Access Compliance Report

Public Rights-of-Way

Intersection ID: 15096	Main Street: OLMSTED_PARK_PL	Cross Street: WINTHROP_AV	Location: SW
ADA ID: 6555A44B8FFE	Ramp Type: PerpDiag	Initial Pass/Fail: Fail	Overall Compliance: No
Severity Score: 25			
Codes/Mitigation Info/Possible Solution		Field Measurements/Component Compliance

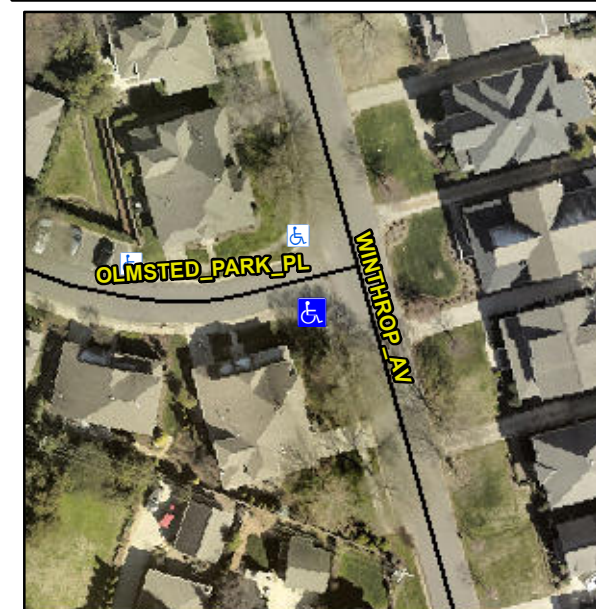
Not Found, R304.2.2, R304.5.3

Compliance	Description	Data	Compliance	Description	Data
N/A	Ramp Length (in)	51.0	No	Ramp Slope (%)	8.7
Yes	Ramp Width (in)	67.0	No	Ramp XSlope (%)	5.5
N/A	Flare Type LT	N/A	N/A	Flare Type RT	N/A
N/A	Flare Slope LT (%)	N/A	N/A	Flare Slope RT (%)	N/A
N/A	Flare Traversable LT?	N/A	N/A	Flare Traversable RT?	N/A
N/A	Landing Length (in)	N/A	N/A	DWS Provided?	N/A
N/A	Landing Width (in)	N/A	N/A	DWS Contrast?	N/A
N/A	Landing Slope (%)	N/A	N/A	DWS Length (in)	N/A
N/A	Landing X Slope (%)	N/A	N/A	DWS Full Width?	N/A
N/A	Landing Curb? (Y/N)	N/A	N/A	DWS Offset (in)	N/A
N/A	Shared Landing?	N/A			
N/A	Gutter Ponding?	N/A	N/A	Gutter Slope (%)	N/A
N/A	Gutter Lip Ht (in)	N/A	N/A	Gutter X Slope (%)	N/A
N/A	Painted X Walk1?	No	N/A	Painted X Walk2?	No
	X Walk 1 Direction	To E		X Walk 2 Direction	To N
N/A	X Walk 1 Width (in)	N/A	N/A	X Walk 2 Width (in)	N/A
	X Walk 1 Slope (%)	2.8		X Walk 2 Slope (%)	1.7
	X Walk 1 X Slope (%)	2.3		X Walk 2 X Slope (%)	1.4

Remove & Replace Curb Ramp With Two New Directional Ramps or Equivalent.
